ECE/TRANS/WP.29/2010/22
18 December 2009

Proposal for Supplement 5 to the 03 series of amendments to Regulation No. 48
(Installation of lighting and light-signalling devices)

Submitted by the Working Party on Lighting and Light-Signalling */

VISIBILITY OF CONSPICUITY MARKINGS TO THE REAR, FRONT AND
SIDE OF A VEHICLE

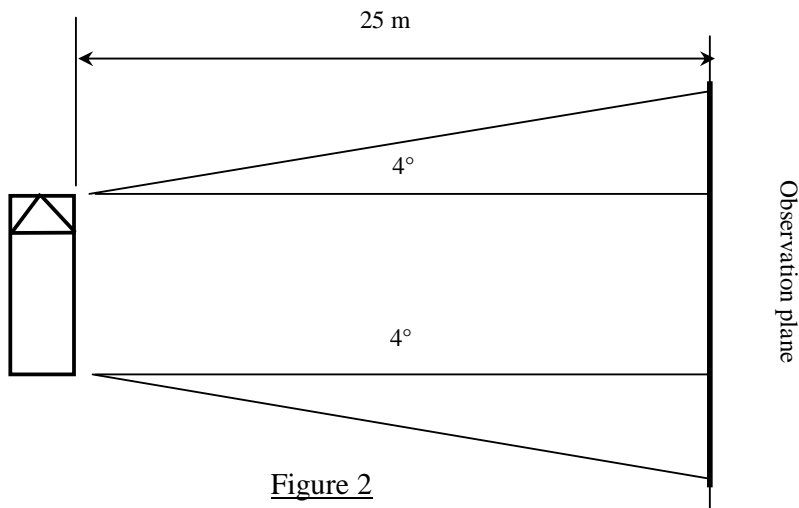
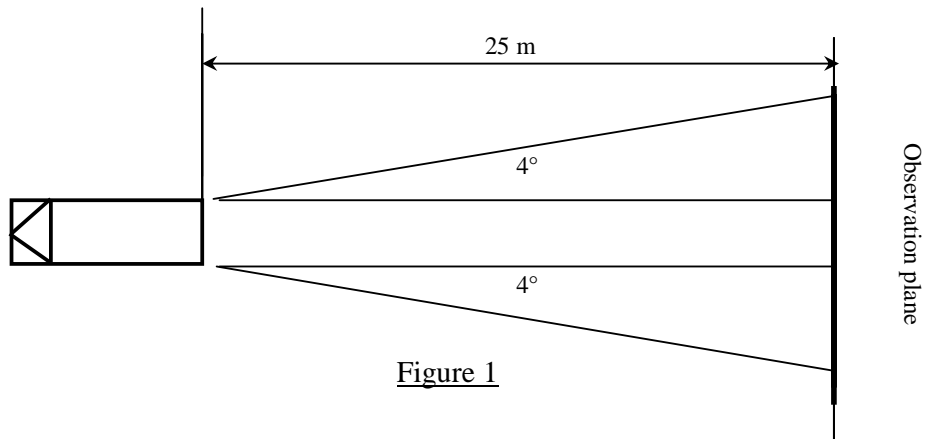
Annex 11, amend to read:

"Annex 11

(see paragraph 6.21.5. of this Regulation)
